PROPOSAL TO DESIGN AND FABRICATE
CURSOR GENERATING CIRCUITRY (U)

Addendum 4 to
Proposal No. C126-CP65

PROPOSAL TO MODIFY FLIR-3
SYSTEM FOR IMPROVED PERFORMANCE

Proposal No. C126-CP65
Part 6
7 December 1966

FIGURE 1.

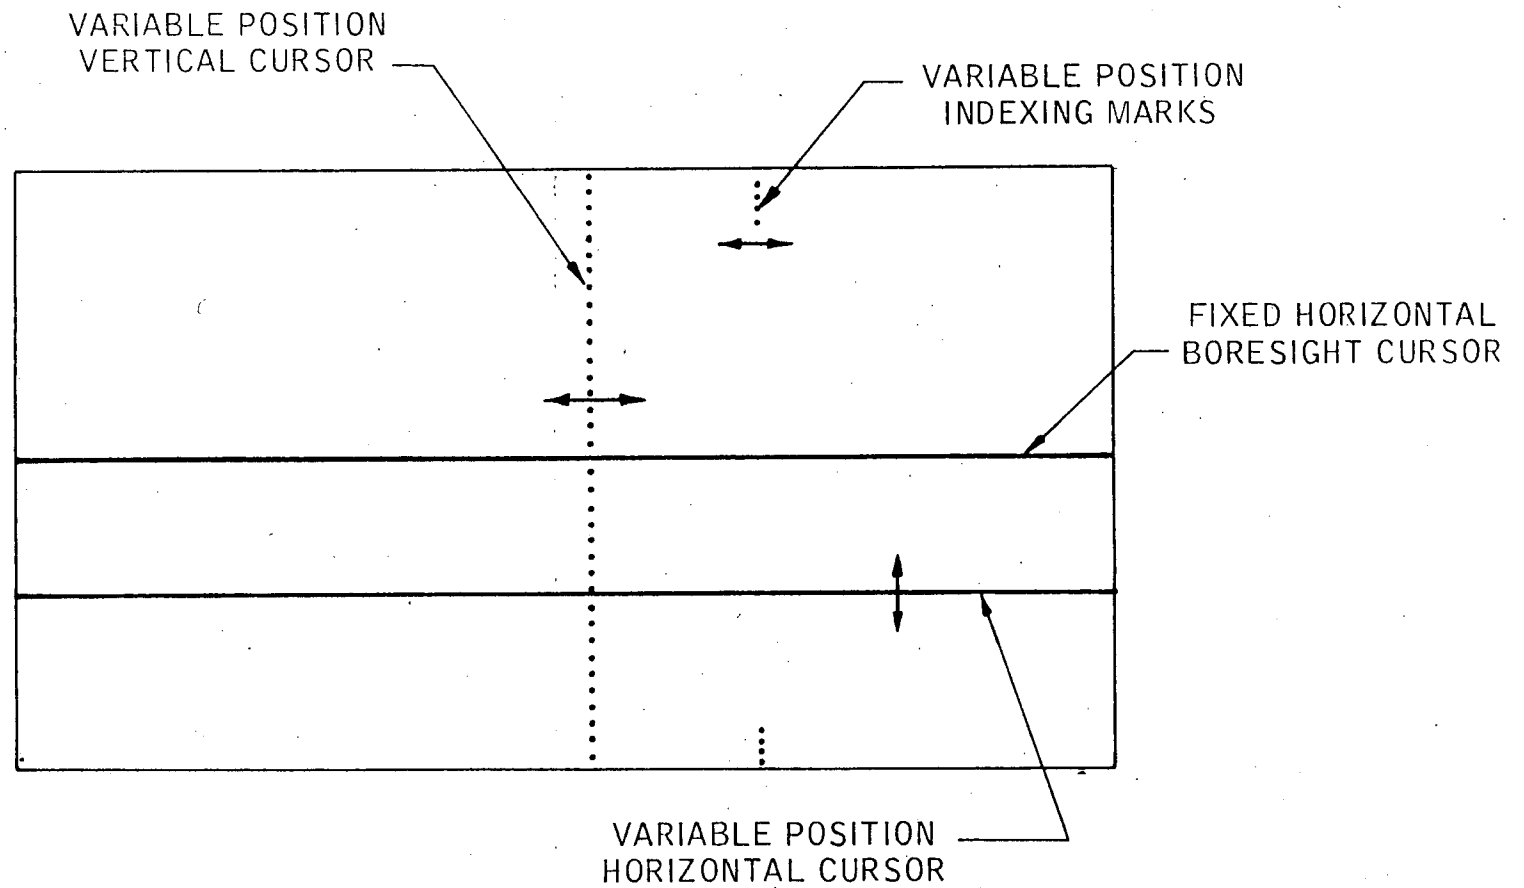
The cursors described above will be generated electronically and displayed on the face of the crt as bright lines. Figure 1 shows the proposed format on the display.

FIGURE 2.

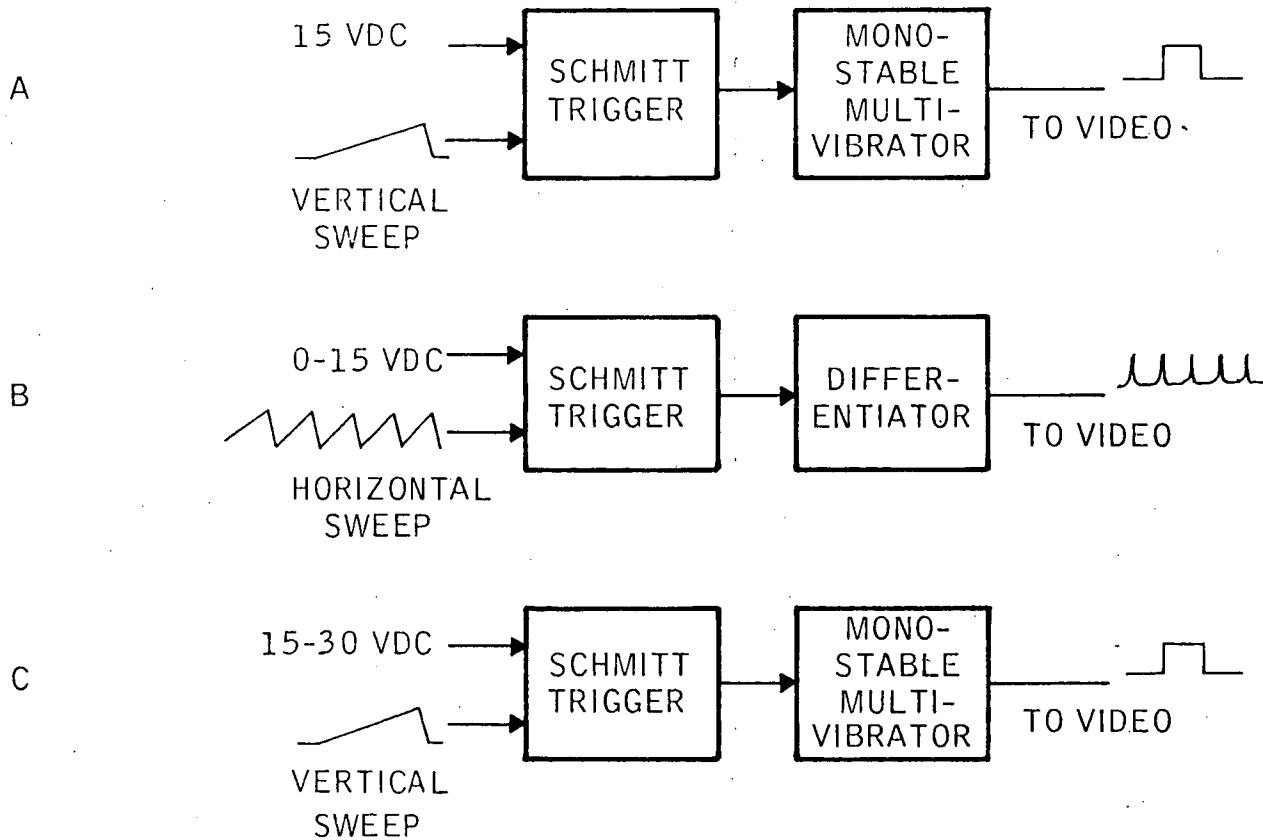
Position of the vertical cursor is determined by the variable-dc-voltage level which operates on the horizontal sweep sawtooth wave. Peak voltage of the horizontal sweep is 15-VDC. Figure 2B shows the block diagram of the circuitry required.

The variable location horizontal cursor is obtained in the same manner as the boresight cursor. Vertical location is determined by the variable dc-level added to the sawtooth waveform. Figure 2C shows the block diagram.

FIGURE 3

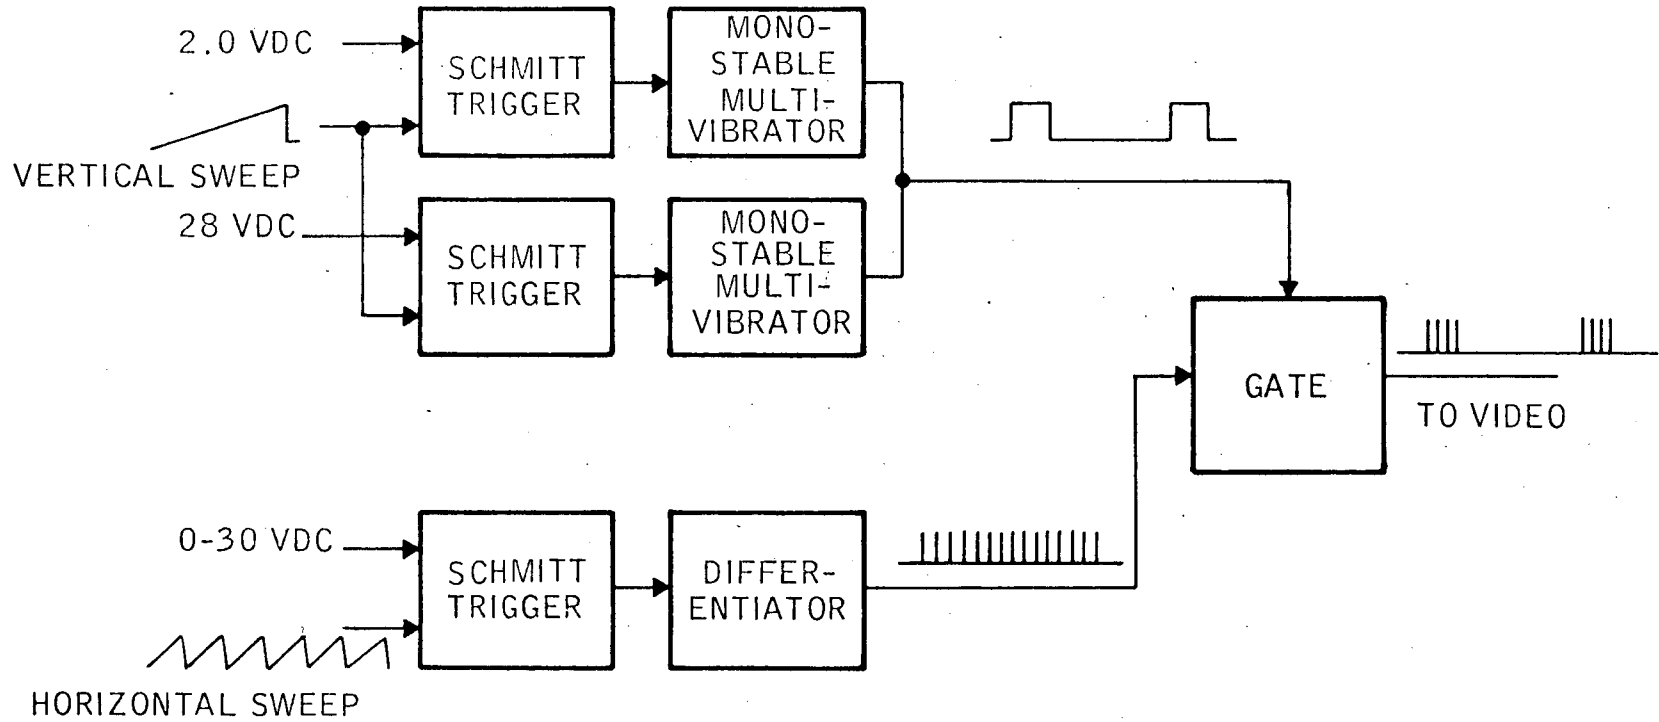
The two, fixed dc-voltages are chosen to locate the indexing marks vertically. An input of 2-VDC will fix the top index while the 28-VDC input will locate the bottom index. Width of the square-waves out of the multivibrators is adjustable and determines how many pulses pass to video and therefore control the vertical length of the indices. Figure 3 shows the block diagram.

Figure 4

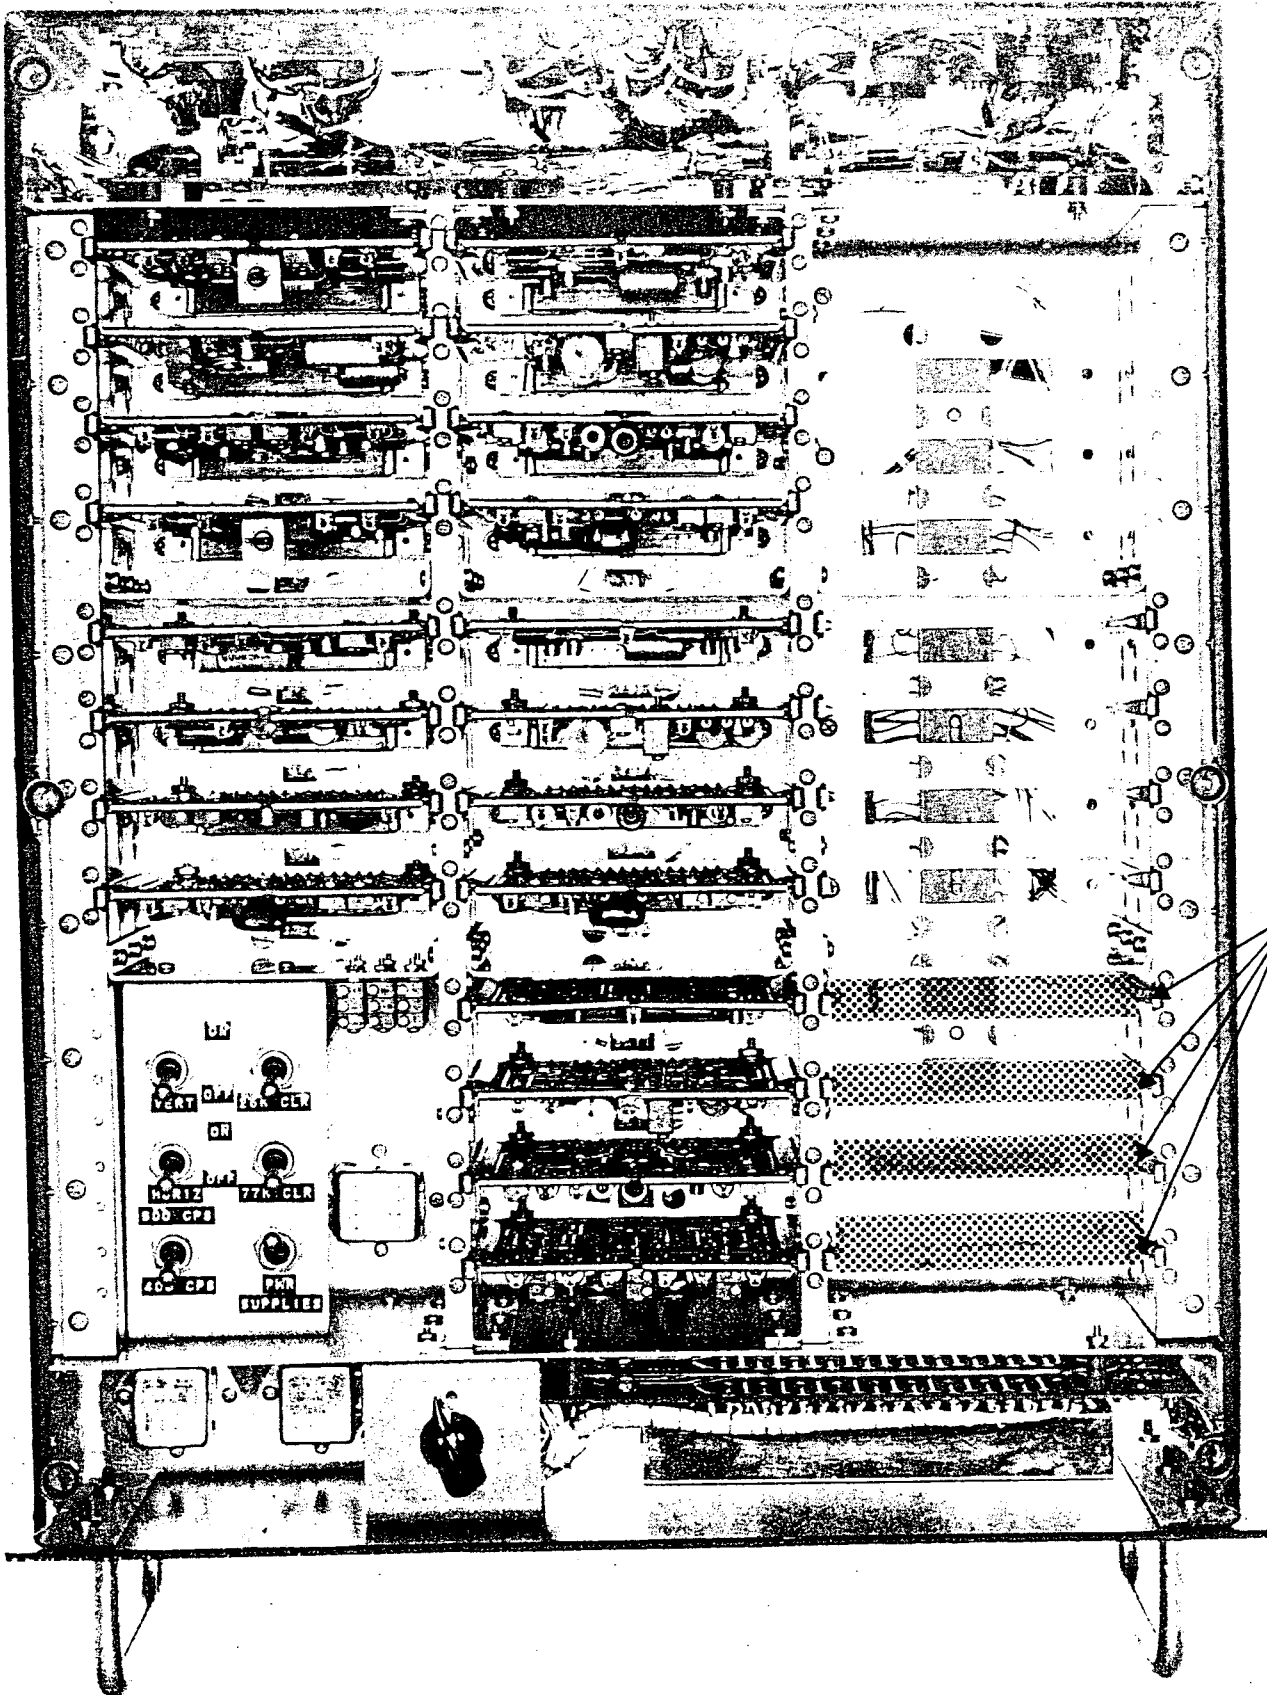
Figure 4 shows the proposed location of the printed circuit boards in the electronics unit. Figure 5 is the bottom view of the electronics unit which shows the cable harness and terminal block. The terminal block will be moved to accommodate installation and wiring of the circuit-board connectors. Cable harness modification will also be necessary.

FIGURE 1

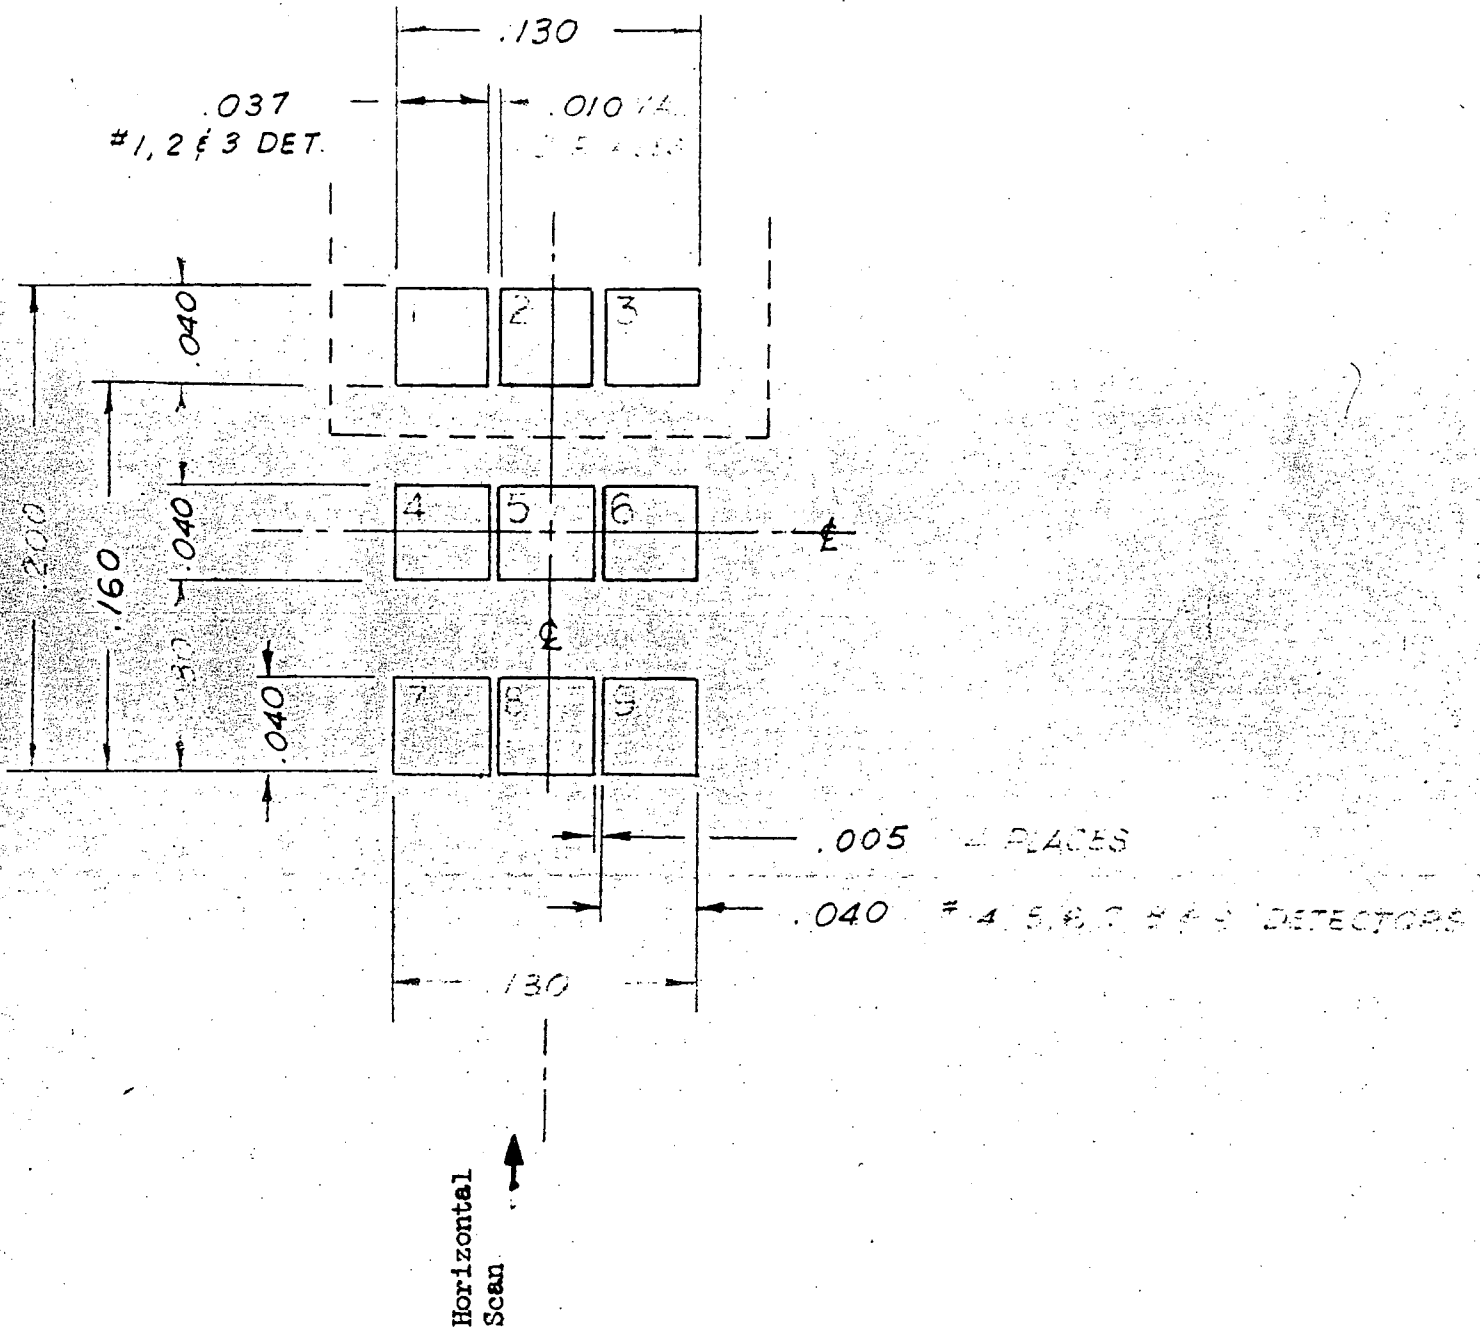
The primary modification of the scanner unit involves installation of a revised detector array. The configuration of the new array is shown in Figure 1. This configuration allows operation of both detectors at 26°K in a single cooler. This modification allows removal of the dichroic mirror which accounts for 50% transmission loss at 14 microns.

The detector is oriented in the configuration shown to obtain the smallest possible image plane. The InSb array is a wafer substrate with the sensitive areas etched by photographic process. The .010 inch spacing will insure negligible cross talk and can be controlled within a few thousands of an inch.

The Ge:Hg bars will be indium soldered to individual copper substrates. The bars are lapped to the .040 thickness. Thickness of the copper substrates is extremely uniform and usually made .002 to .005 inch thicker than the detector bar width. Bar location on the substrate is held within .001 inch of the desired location. By stacking the substrate-bar subassembly, very accurate spacing can be achieved. This assembly technique allows individual bars to be replaced in case of failure.

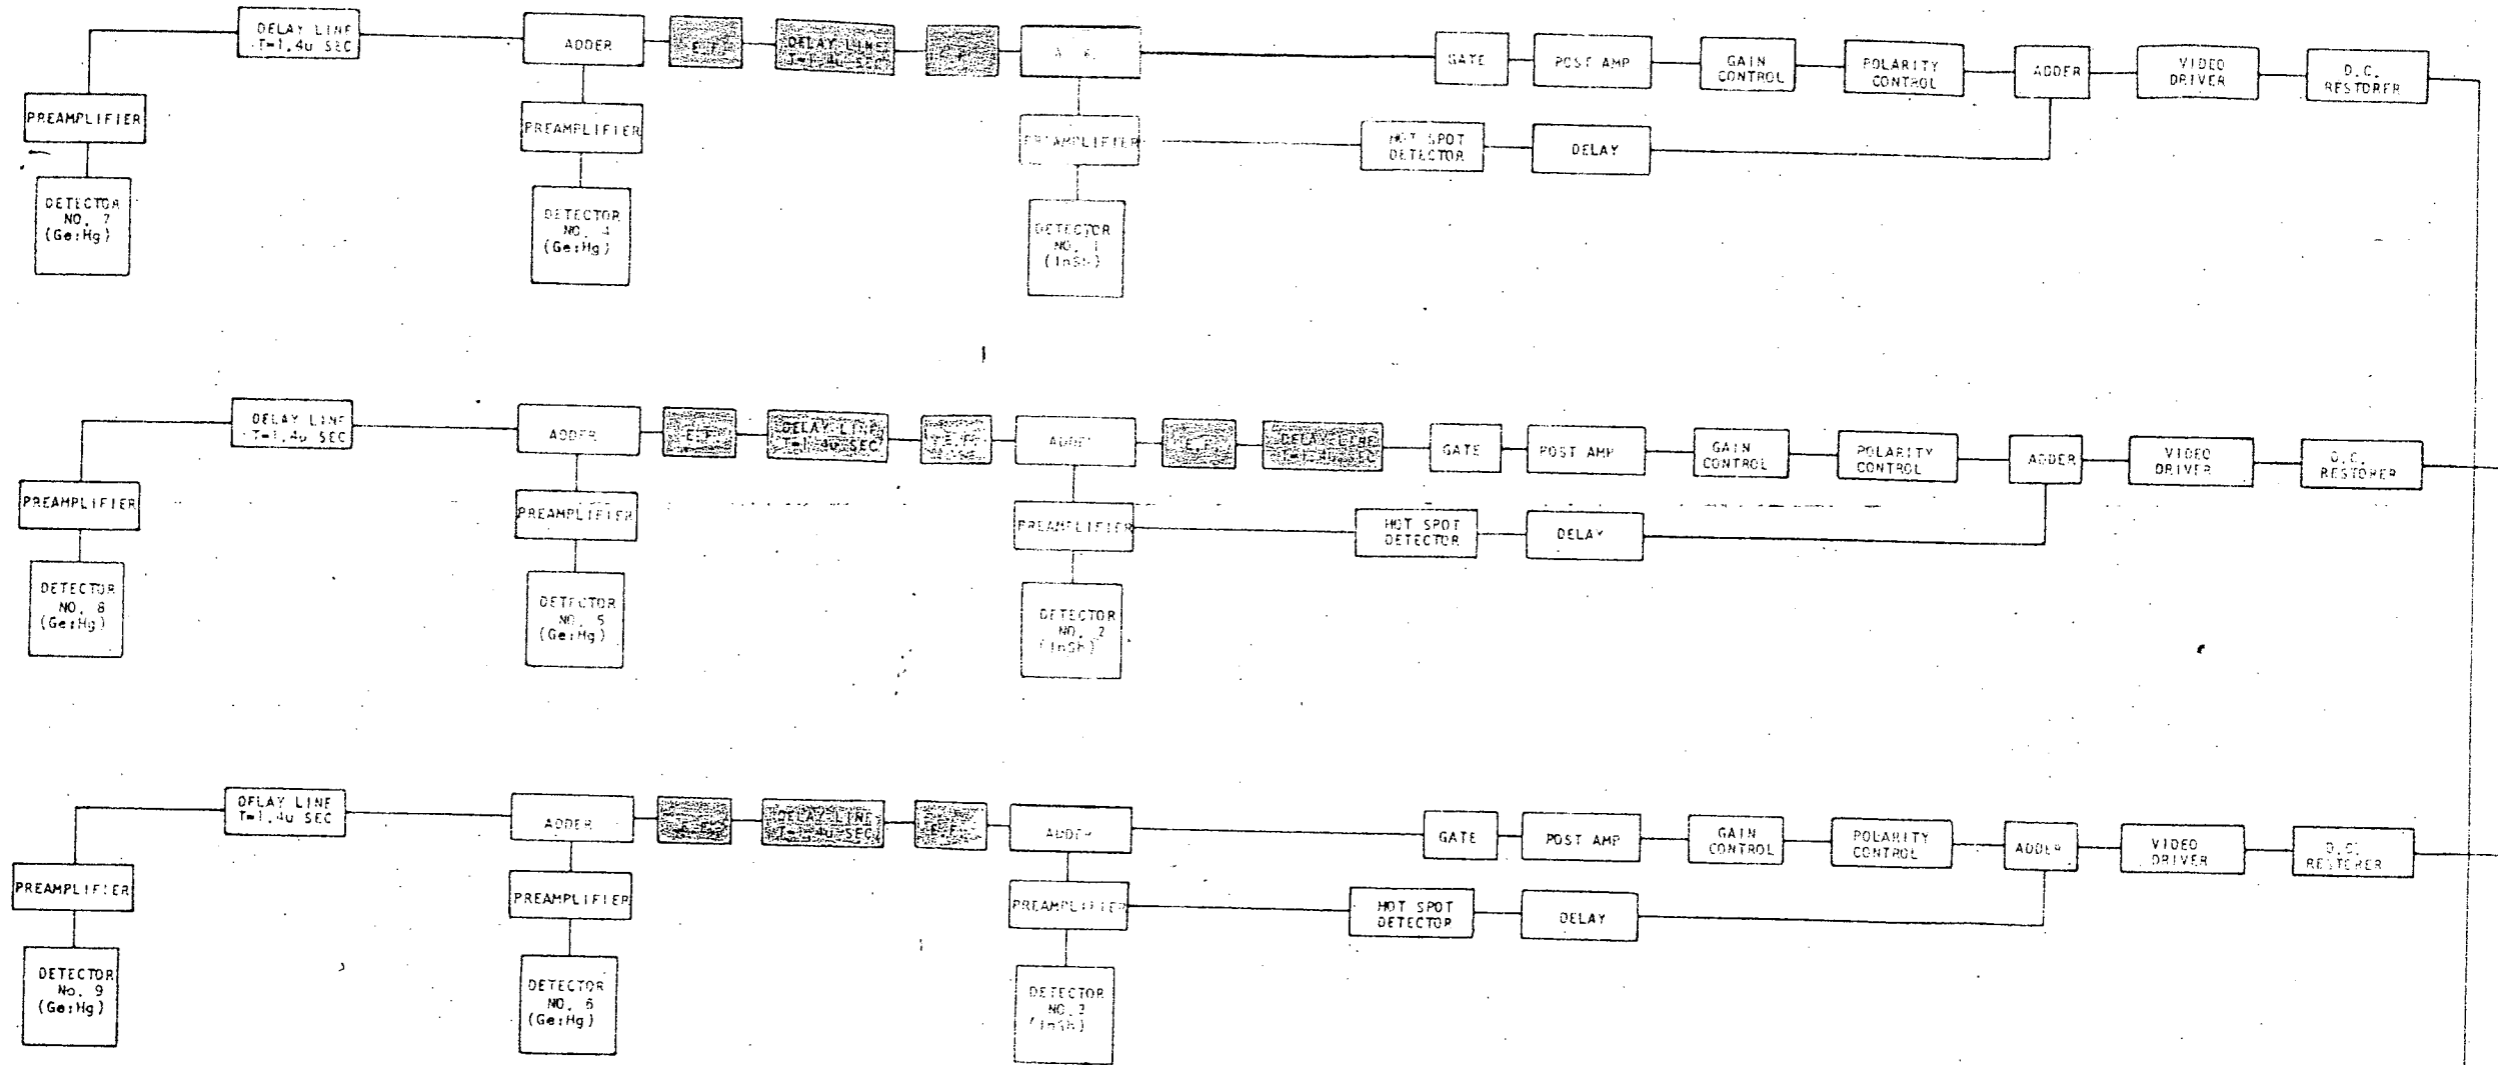
Figure 2 shows the video block diagram with changes noted in red. The new detector configuration with appropriate delay lines will superimpose video from all detectors. Detectors 7, 8 and 9 will be electronically delayed and added to 4, 5 and 6. This summed video is then delayed and added to video from detectors 1, 2 and 3. A seventh delay line then delays the summed video from detectors 2, 5 and 8 to correspond with the No. 2 MATRICON grid displacement.

Since all video is now superimposed, the second set of adder circuits (adjusted externally by control unit knob) can be modified to allow 100% of each spectrum to be simultaneously displayed. Previously, as video from one spectrum was increased, the other spectrum was proportionally attenuated.
